# MEMORANDUM

**FILE NO.:** USE2006-00071 - Conditional Use

**PROPOSAL:** A Conditional Use Permit for a Driveway in an Un-named Right-of-Way.

**ENTRANCE  
POINT  
BUSINESS PARK**

**ATTACHMENT A**

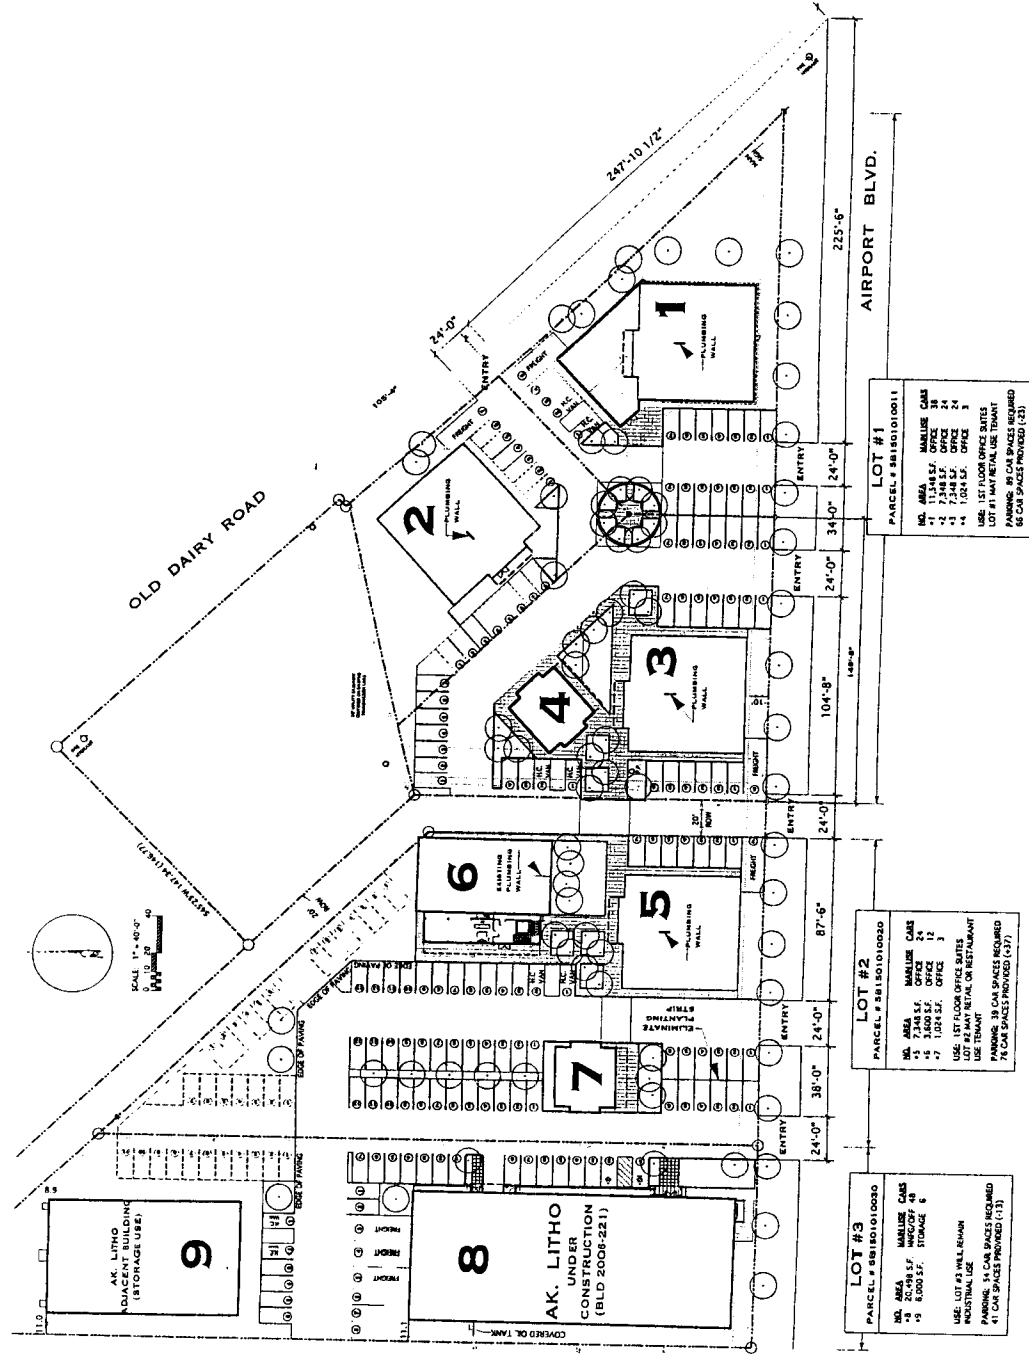
Building 6 (Attachment A) is an existing structure, and the encroachment into the ROW shown at the northeast corner of this structure has existed since the building was constructed in 1975.<sup>2</sup> CBJ code does provide a mechanism for granting permits for structures which encroach into dedicated ROWs; however, CBJ §62.55.040(b)(2) and -050(1) require that the encroachment pre-date January 1, 1960 in order for an encroachment permit to be granted for it. As such, a non-code ordinance would be

required in order to permit the existing encroachment. The lack of such authorization results in a situation where the CBJ may remove the structure at any time for purposes of maintaining or developing the ROW. Approval of the permit considered herein does not in any way constitute an approval or endorsement of the existing encroachment.

A final concern regarding the use of the ROW and public health or safety concerns the encroachment of Building 6<sup>3</sup> into the subject ROW. According to as-built surveys of the property, the encroachment is 1.3' at the corner of the building. As the ROW is 20' in width, the encroachment reduces the functional width of the ROW to 18.7'. CBJ §49.40.230(b)(2) requires a minimum access aisle width of 19' where parking spaces will be at 0° to a two-way drive aisle. There are no parking spaces adjacent to this portion of the ROW, so this standard does not apply; however, it is indicative that a 19' wide drive aisle is wide enough for two-way traffic and adequate space for parallel parking. It stands to reason that a drive aisle which is slightly narrower than 19' is wide enough for two-way traffic with no directly adjacent parking.

Given that the ROW is not proposed to be paved at or north of the place where the encroachment exists, and that the parking off of the ROW north of the encroachment will be overflow parking and see less use than other parking areas in the development, there will be less traffic within the ROW at the point of the encroachment than there will be immediately south of the encroachment. This reduction in traffic volumes results in a reduction in the level of concern about any potential impacts of the encroachment on public safety. Staff recommends that in order to further reduce public safety concerns related to the encroachment into the ROW, a condition of approval of the requested permit be that signs be placed on either side (to the north and south) of the encroachment alerting drivers to the narrow width of the drive aisle and to the fact that two-way traffic can be expected in this location.

In addition to the information already shown on the plans, the plans should show traffic flow patterns (directional arrows), curb radii, a parking schedule, and lighting in accordance with CBJ Code 49.40.220.

1. Details of curb radii shall be submitted for review with any application for ROW or building permits associated with proposed work in the ROW.
2. Signs approved as to content and form by the Community Development Department shall be placed where they are visible to drivers approaching the encroachment of Building 6 into the ROW. Such signs shall be installed prior to issuance of a Temporary or Permanent Certificate of Occupancy for any new or remodeled building on Lot 2, or for any building on Lot 1 for which required parking is provided on Lot 2.
